CARRIAGE OF CARGOES AND CONTAINERS

Application of the draft amendments to paragraphs 8.4.3.1 and 8.4.3.2 of the IGC Code pertaining to upstream pressure losses of pressure relief valves

Submitted by China, Panama, Republic of Korea and IACS

Figure 1

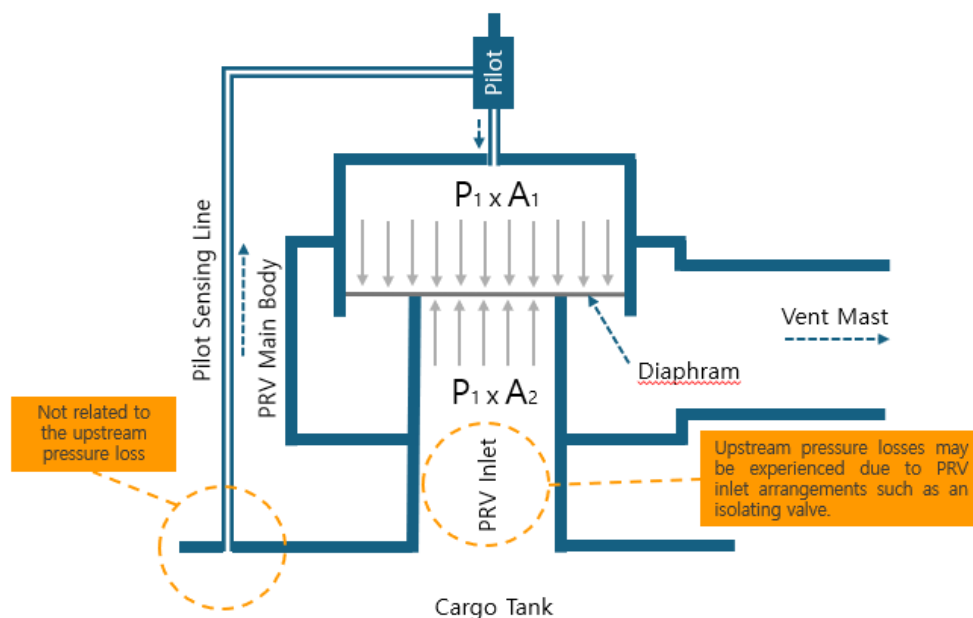
9 For pilot-operated PRVs, however, upstream pressure losses may not adversely affect PRV functionality when the pilot senses directly from the tank dome rather than from the PRV inlet, as previously recognized in paragraph 8.4.3.2 of the IGC Code (i.e. the deleted sentence). Accordingly, the previous paragraph 8.4.3.2 has served as the technical basis permitting upstream pressure losses exceeding 3%, where the sensing line was not directly supplied from the PRV inlet (i.e. sensing directly from the tank dome). The illustration in figure 1 below explains this mechanism. This principle remains valid in many installations. However, document CCC 9/4/2 highlighted the need for clearer requirements on the sizing and arrangement of pilot sensing lines to ensure consistent performance across different designs.

10 Nevertheless, the draft amendments to paragraph 8.4.3.2 remove the previous requirement described above, while introducing new design requirements for the sizing and drainage of pilot-operated PRV sensing lines. Consequently, if applied retroactively, existing gas carriers constructed on or after 1 July 2016 but before 1 July 2028 would need to undergo additional verification to demonstrate compliance with the draft amendments.

11 In cases where compliance cannot be confirmed, physical modifications to the PRV inlet arrangements, including the replacement of isolating valves, upsizing PRV, and/or adjacent piping arrangements, etc. would become unavoidable. The submitters further note that document CCC 9/4/2, which originally proposed the relevant amendments, appears not to have provided sufficient consideration of retroactive application or their potential technical and operational implication. Given also that the amendments to the IGC Code are expected to enter into force on 1 July 2028 without a grace period, existing gas carriers could face significant design and compliance challenges unless the applicability of the draft amendments to paragraphs 8.4.3.1 and 8.4.3.2 is appropriately limited.

16 In light of the above, the submitters propose that the deleted sentence in the draft amendments to paragraph 8.4.3.2 of the IGC Code be retained, and that the draft amendments to paragraphs 8.4.3.1 and 8.4.3.2 of the IGC Code be modified to apply to new ships, as follows:

8.4.3.2 Pilot-operated PRVs shall be unaffected by inlet pipe pressure losses when the pilot senses directly from the tank dome. For ships constructed on or after 1 July 2028, pPilot-operated PRV sensing lines shall be sized to avoid pressure losses which affect the function of the PRV. The sensing line shall be self-draining and free from liquid pockets."
